Lightcomm Technology Co., Ltd.
UNIT 1306 13/F ARION COMMERCIAL CENTRE, 2-12 QUEEN'S ROAD WEST,
SHEUNG WAN HK

Class II Permissive Change Letter

FCC ID: **XMF-MID1035**

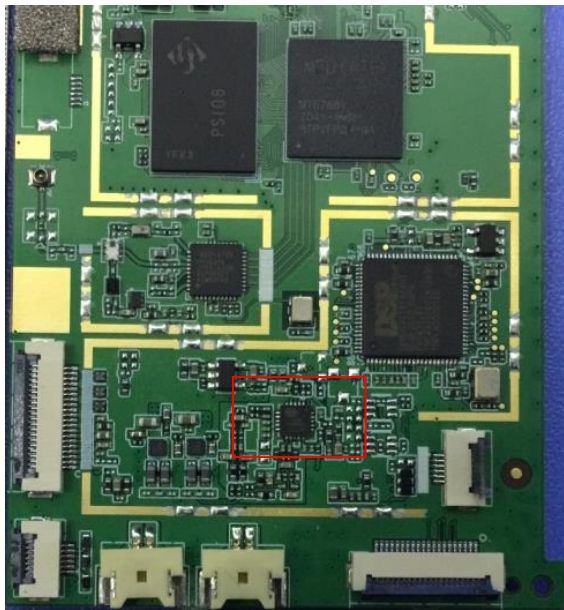
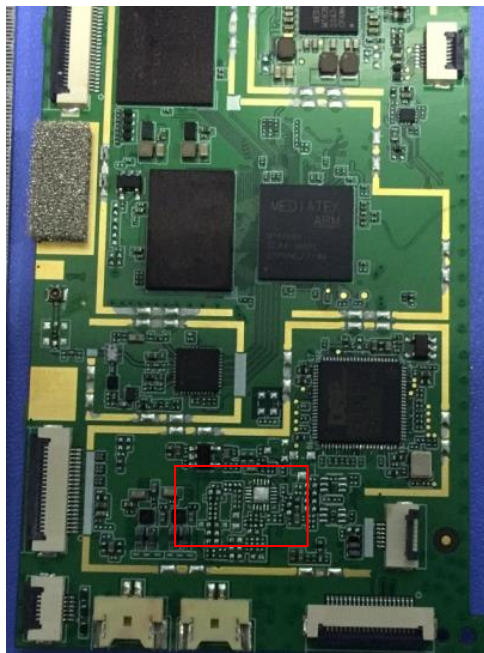
There is **only change of non-transmitter portions**, Conducted Emissions & Field Strength of Spurious Radiation testing was performed to demonstrate RF compliance

The new PCB delete the audio noise reduction **IC module(AC107)**.
